HISTORIC AND DESIGN REVIEW COMMISSION

August 04, 2021

HDRC CASE NO:	2021-359
ADDRESS:	905 N PINE ST
LEGAL DESCRIPTION:	NCB 531 (PINE AT HAYS {IDZ}), BLOCK 13 LOT 23
ZONING:	IDZ, H
CITY COUNCIL DIST.:	2
DISTRICT:	Dignowity Hill Historic District
APPLICANT:	John Cooley/Terramark
OWNER:	901 PINE LLC
TYPE OF WORK:	Construction of a park space on private property
APPLICATION RECEIVED:	July 15, 2021
60-DAY REVIEW:	Not applicable due to City Council Emergency Orders
CASE MANAGER:	Edward Hall

SITE PLAN

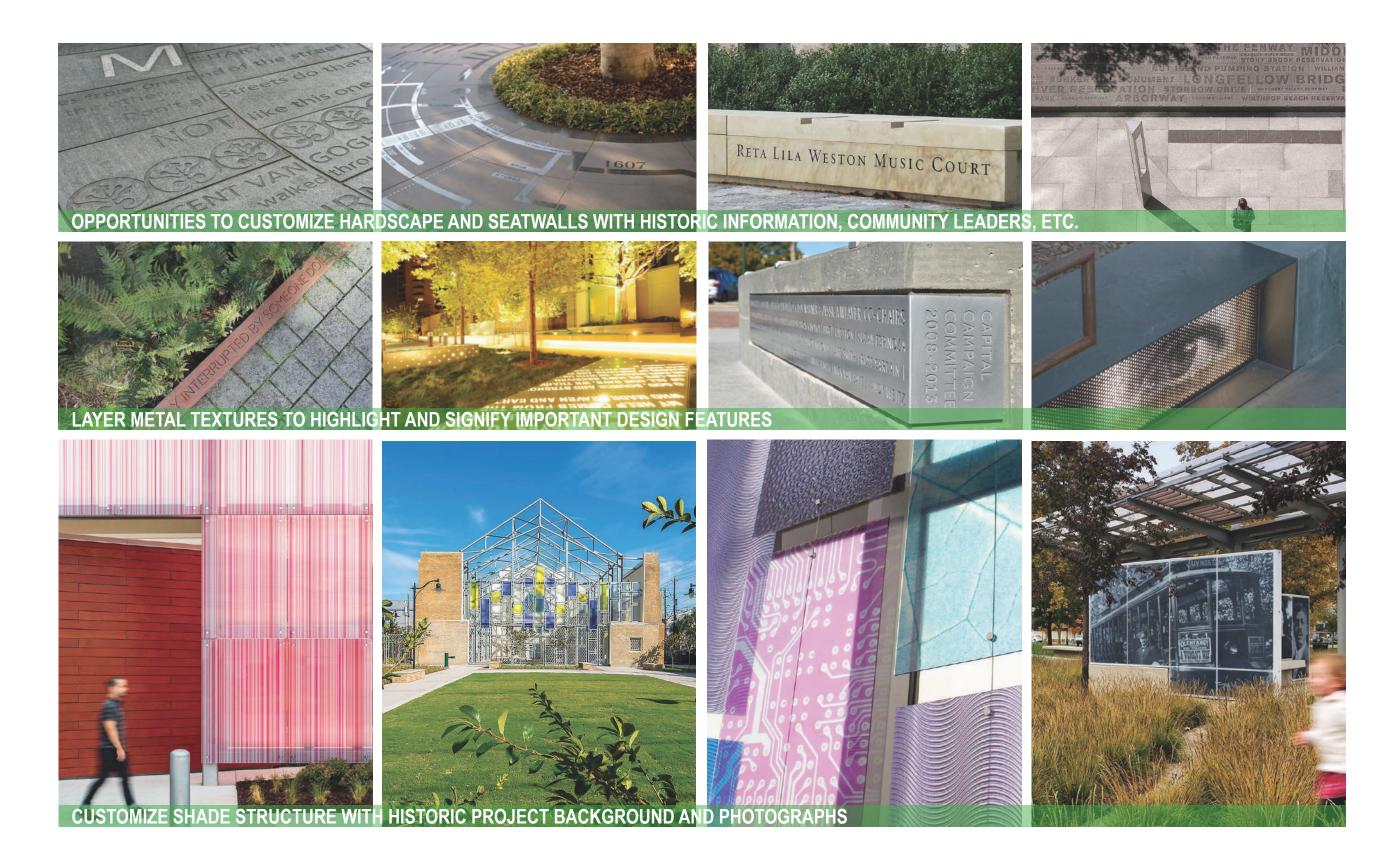
- c. PROPOSED PARK The applicant has proposed park space to be open to the public between the existing structure at 905 N Pine and the right of way at N Pine. The proposed park would feature landscaping and seating elements as well as a steel shade structure. The applicant has noted that a retaining wall of limestone blocks will be installed to create a border at the public right of way as well as to retain landscaping elements due to a change in grade from the park site to the sidewalk at the right of way. Generally, staff finds the proposed landscaping work and park installation to be appropriate as the existing lot does not feature a traditional house to front yard configuration as found historically within the district.

- e. RIGHT OF WAY Staff finds that at no time should park elements, including landscaping materials, fencing or gates interfere with the pedestrian path at the public right of way.

- i. That if signage is proposed, a master signage plan be submitted to the Commission for review and approval.
- ii. That no landscaping or site elements interfere with pedestrian traffic.
- iii. That the applicant submit updated documentation with dimensions and specifications.
